# NTUA Headquarters Complex Office Building

Dyron Murphy Architects Project No. 2015.05

## ADDENDUM No. 1

October 27, 2016

SERVICE CALCULATION FOR "SES" AND "MDP"

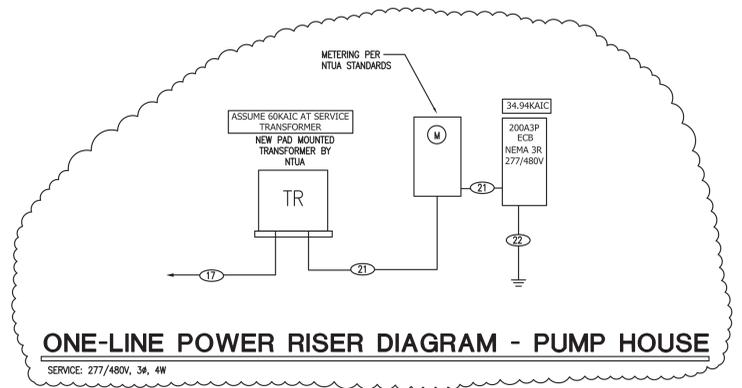
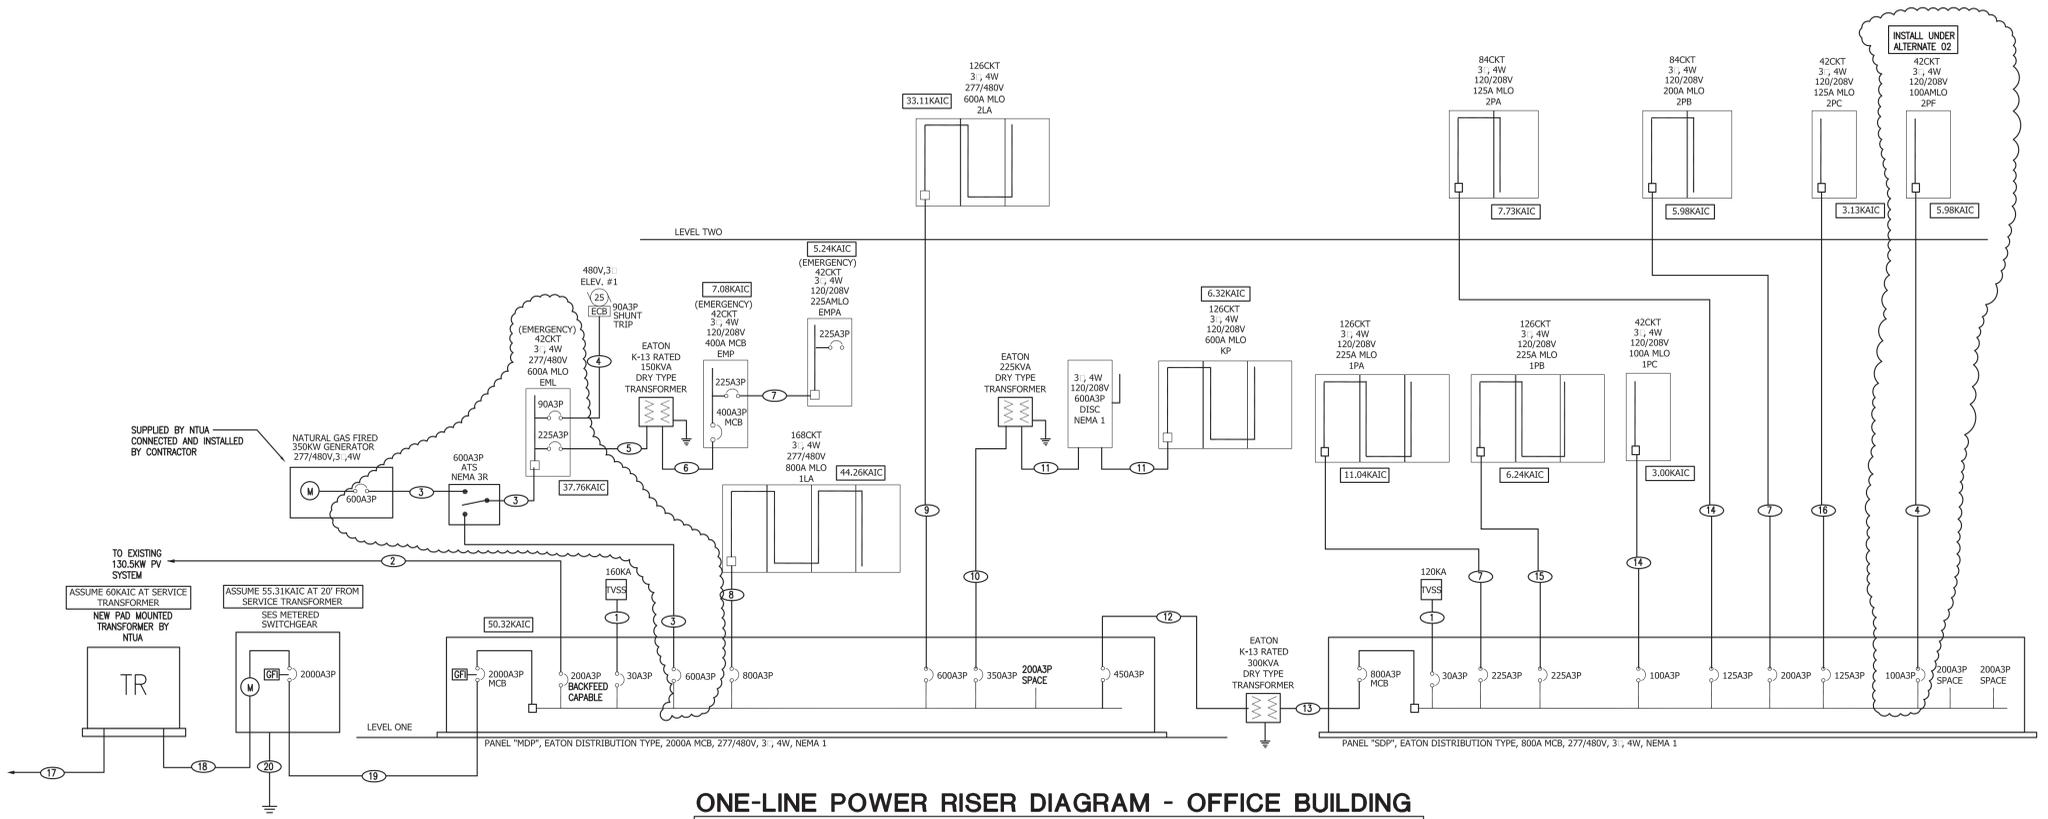
5. Add Fixture Type "S" to Fixture Schedule. Fixture "S" to read:  
"LITHONIA" #2GTL 4 48L SWL MVOLT EZ1 LP835 N100
6. Sheet 602: Panel "EML" Change to 600A MLO.
7. Sheet 603:
  - a. Panel "1PB". All three sections are to be labelled "1PB".
  - b. Panel "KP". All three sections are to be labelled "KP".
  - c. Panel "2LA". All three sections are to be labelled "2LA".
  - d. Panel "2PA". Circuits 56 thru 84 to be 20A1P SPARES.
8. Sheet 604: See attached stamped drawing.
9. Replace Specification Section **26 2416 - PANELBOARDS**, with the attached revised specification.
